United Church

Planning Consultation Response - Design Amendment

June 2026

title:
Proposed Elevations A & B
(United Church)

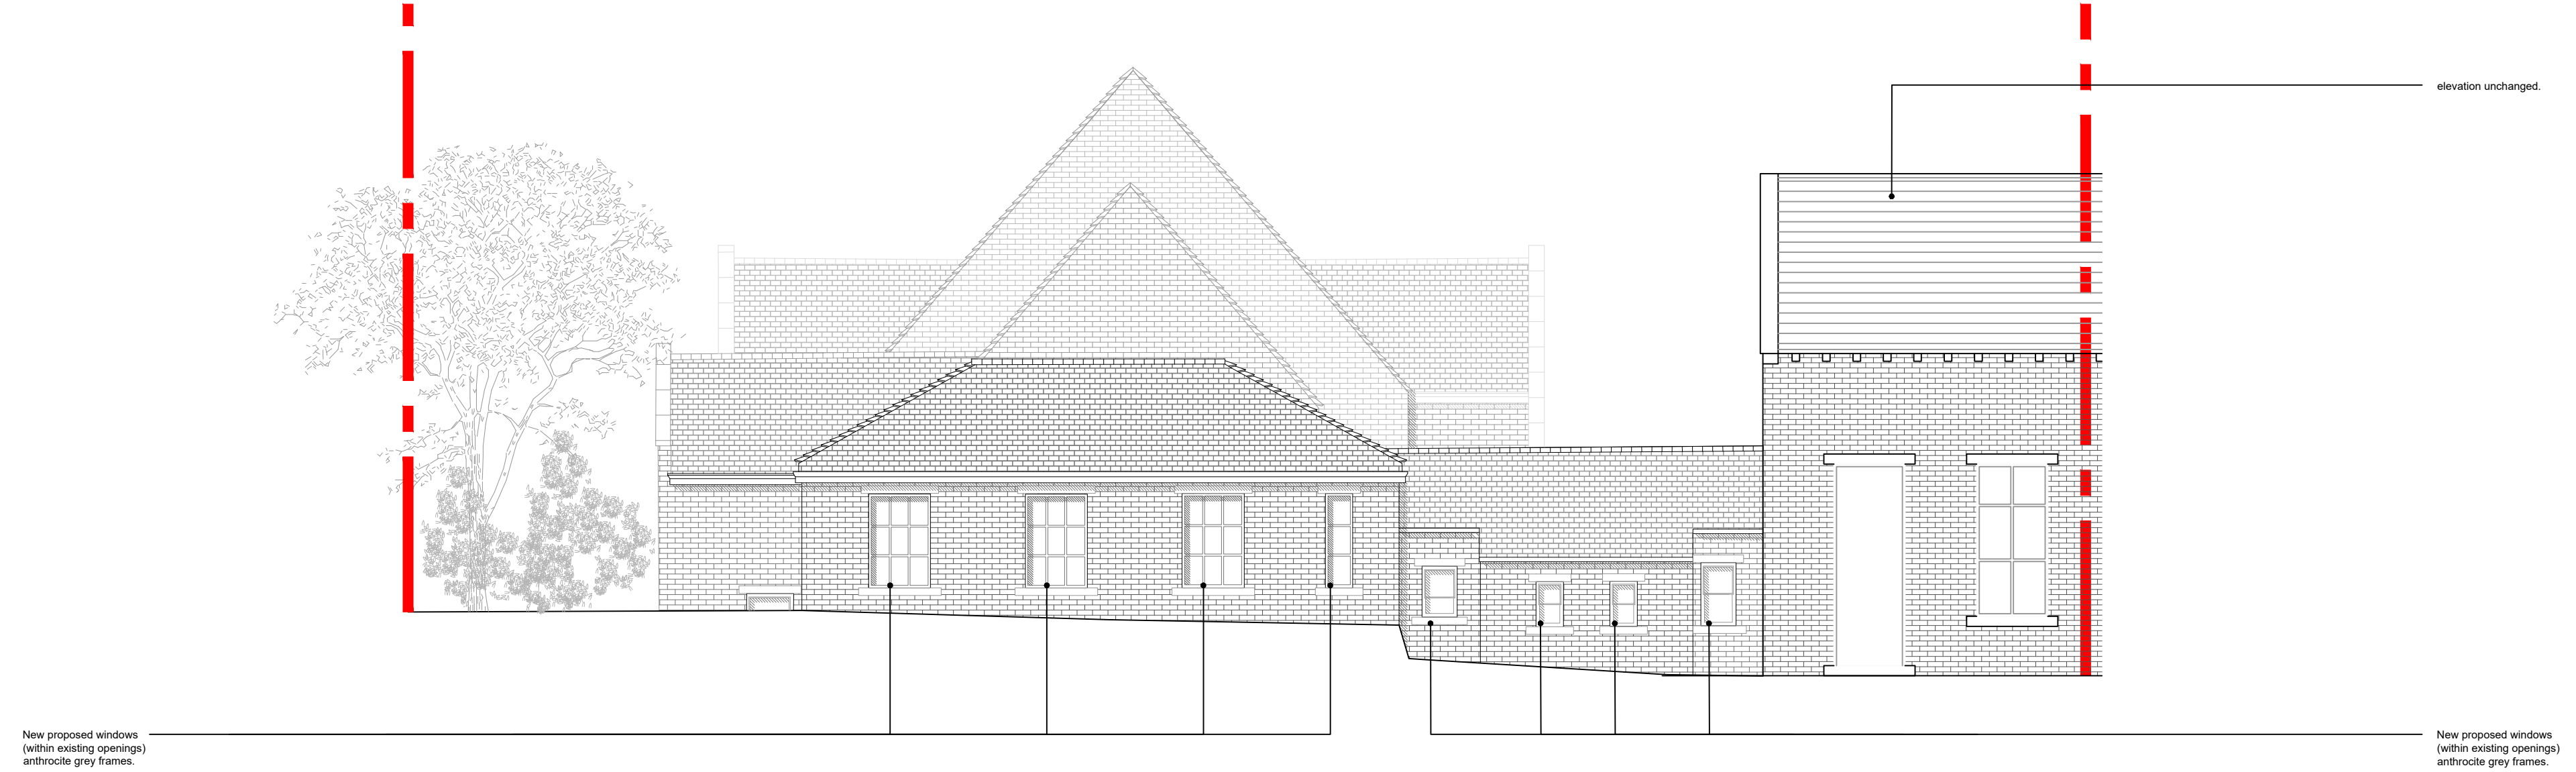
The Conservation Officer expressed concerns regarding the scale and prominence of the proposed rooflights.

In response, the rooflights on Elevations B and D have been reduced in width from 2.5m to 2.0m. The rooflights have also been repositioned and centralised with the gable feature and principal arched window below to improve the overall symmetry and composition of the elevation.

Proposed Elevation D
Scale 1:100

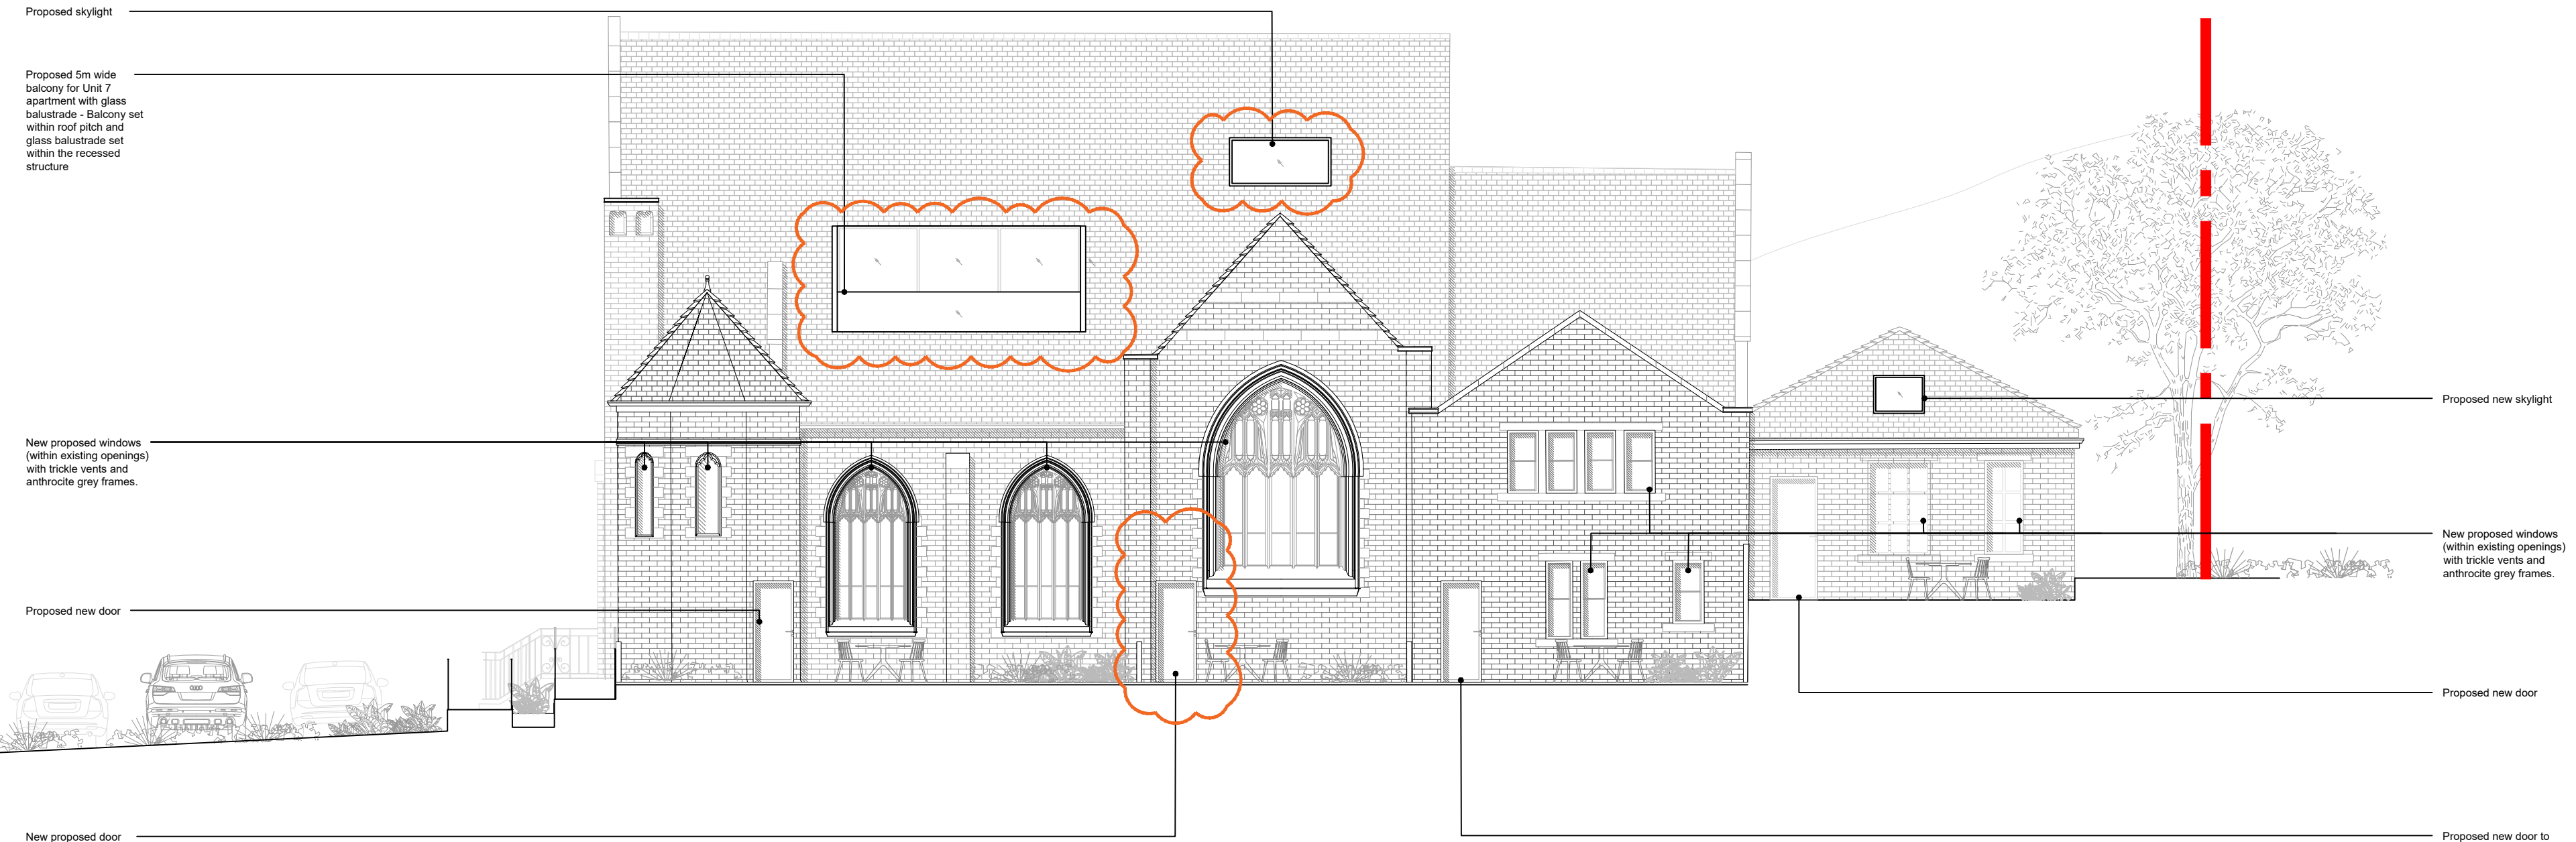
The Conservation Officer raised concerns regarding the relationship between the proposed new entrance door and the adjacent historic arched window on Elevation D.

To improve the visual separation between the existing architectural features and the proposed intervention, the new door opening has been repositioned by approximately 150mm. This amendment increases the amount of retained masonry between the new and existing openings and reduces the visual impact of the proposal on the historic elevation.
